River District Design Commission

OCTOBER 11, 2018

AGENDA

Request a Certificate of Appropriateness at 125 Floyd St. to install six (6) overflow roof scuppers (drains) during roof replacement.

OVERFLOW SCUPPER DETAIL

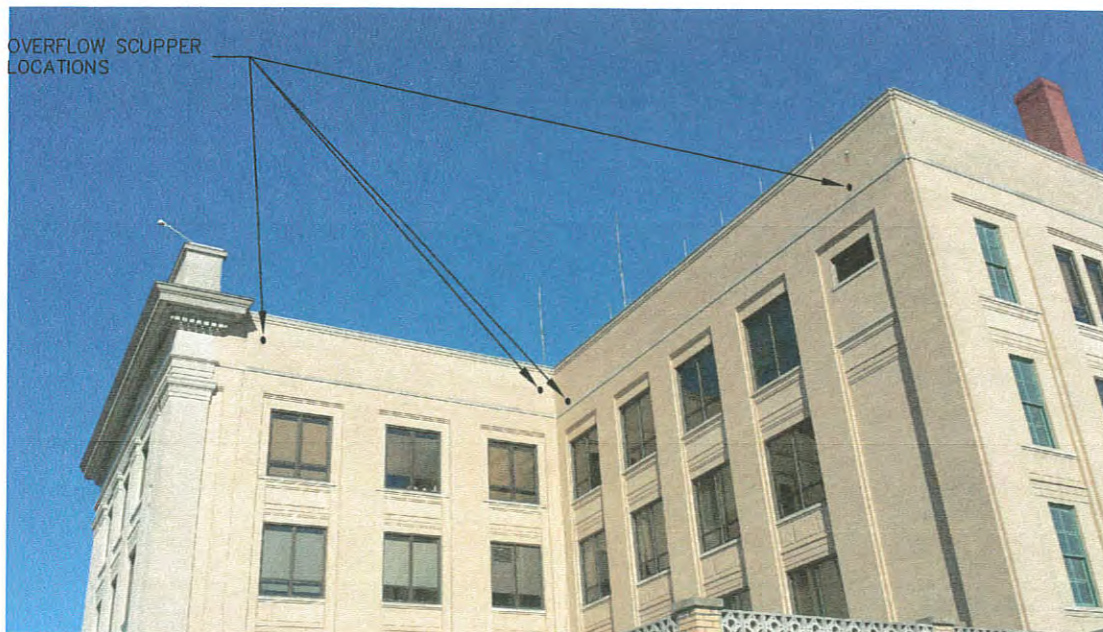
The proposed addition of scuppers aid the existing roof drainage system, use appropriate materials, and match the character of both the building on 125 Floyd St. and other public buildings in the River District. Staff recommends the issuance of a Certificate of Appropriateness at 125 Floyd St. to install six (6) overflow roof scoopers (drains) during roof replacement.

The Crossing- Off Leash Dog Play Park

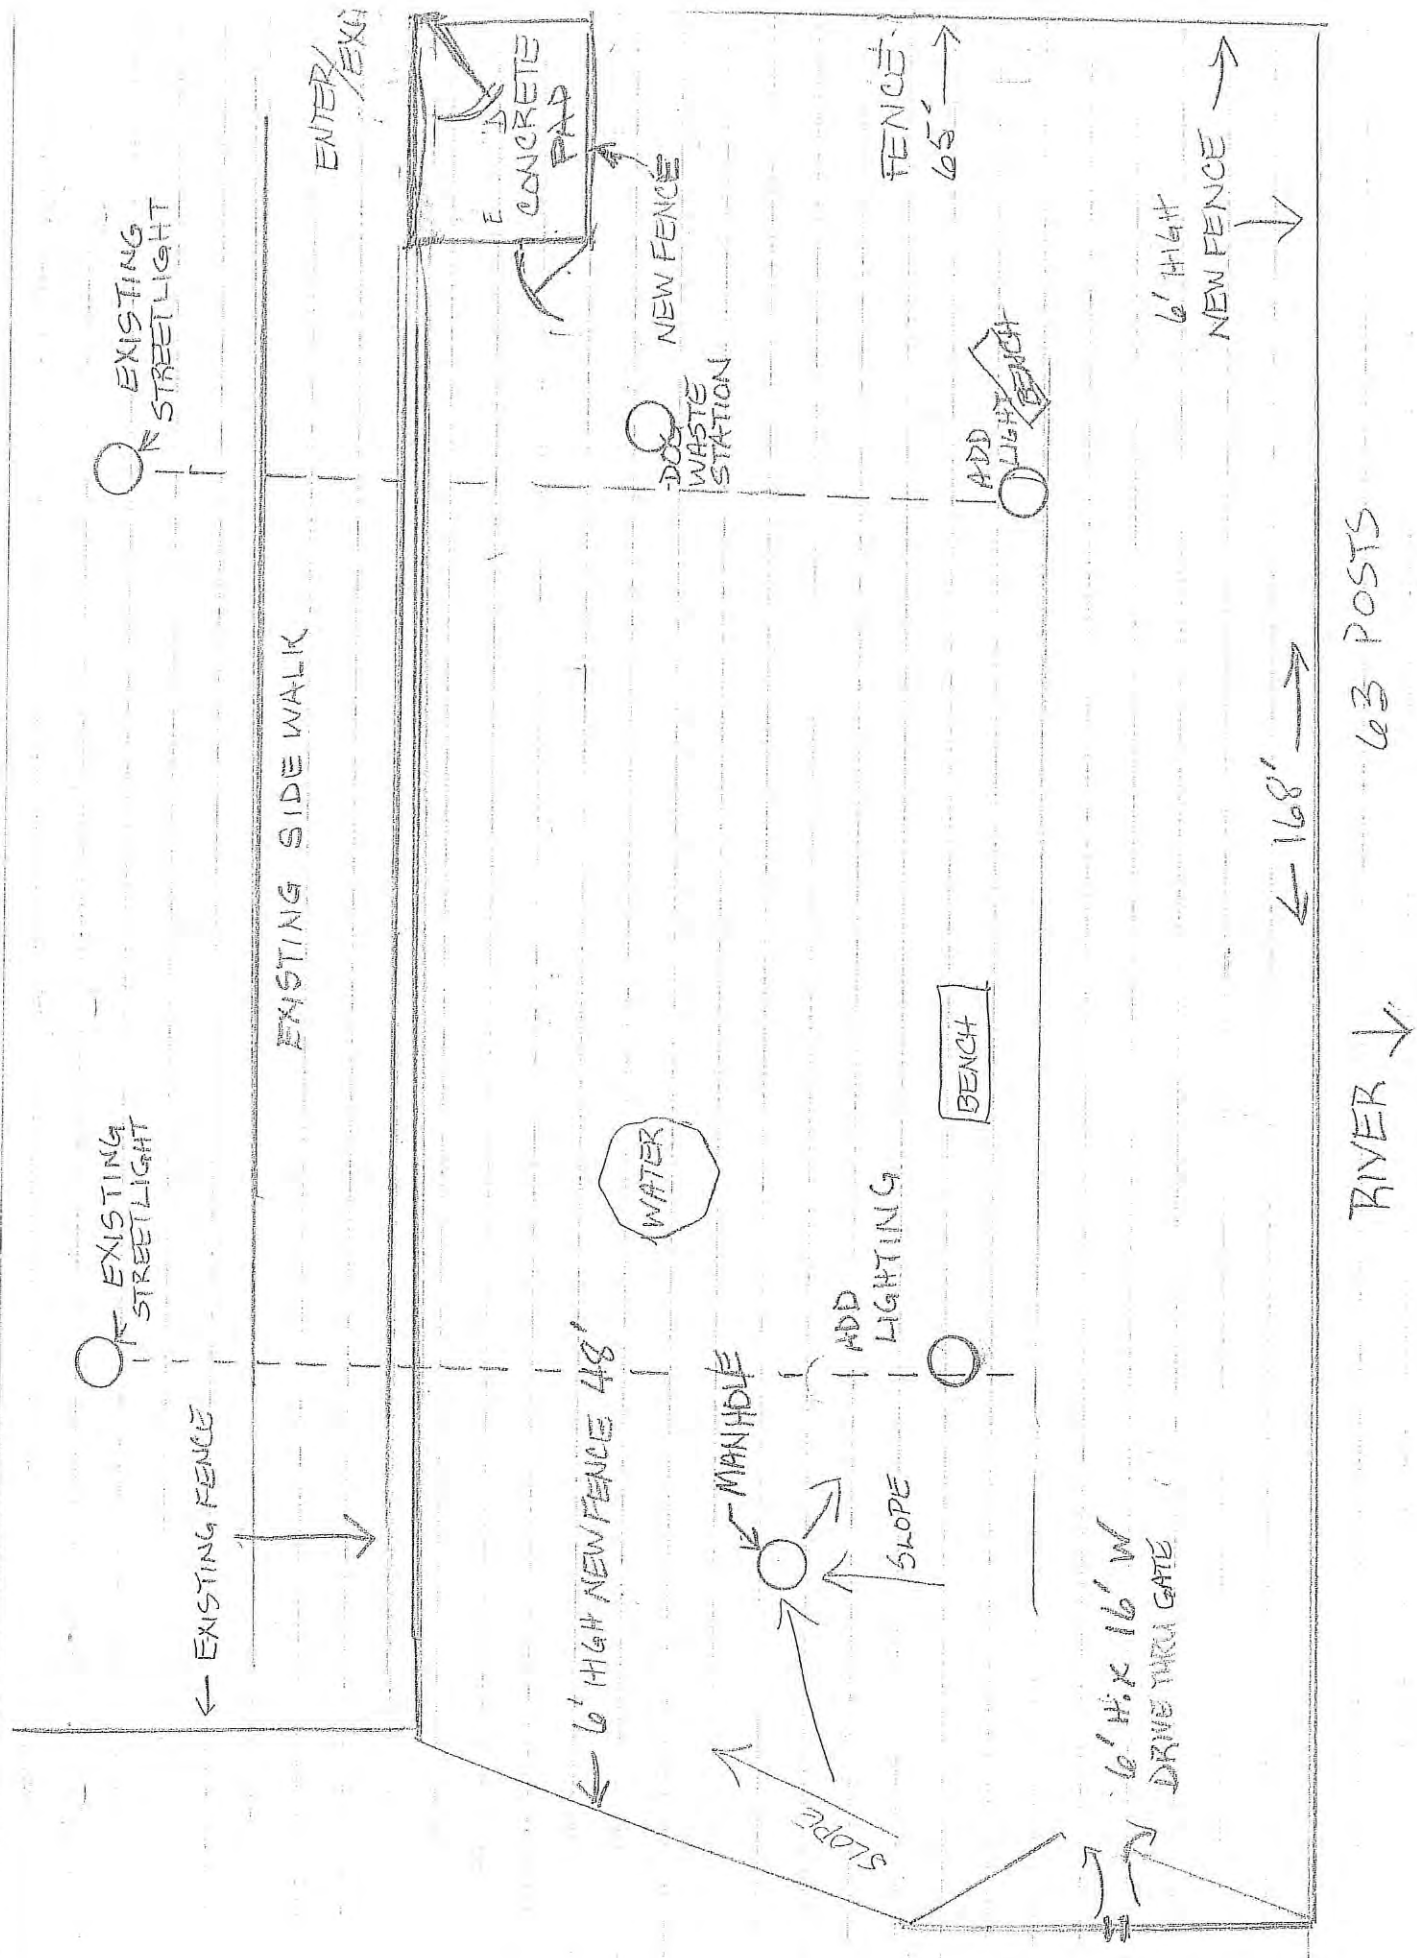
The proposed park adds variety to the available public spaces in the River District, includes convenient amenities for all users (regardless if human or dog), includes proper lighting for safety, includes moveable materials for adaptable use and floodplain consideration, uses similar materials as those found in Carrington Pavilion, and brings further attention to the Dan River and Riverwalk. Staff recommends the issuance of a Certificate of Appropriateness at 667 Craghead St to construct an off-leash dog park.
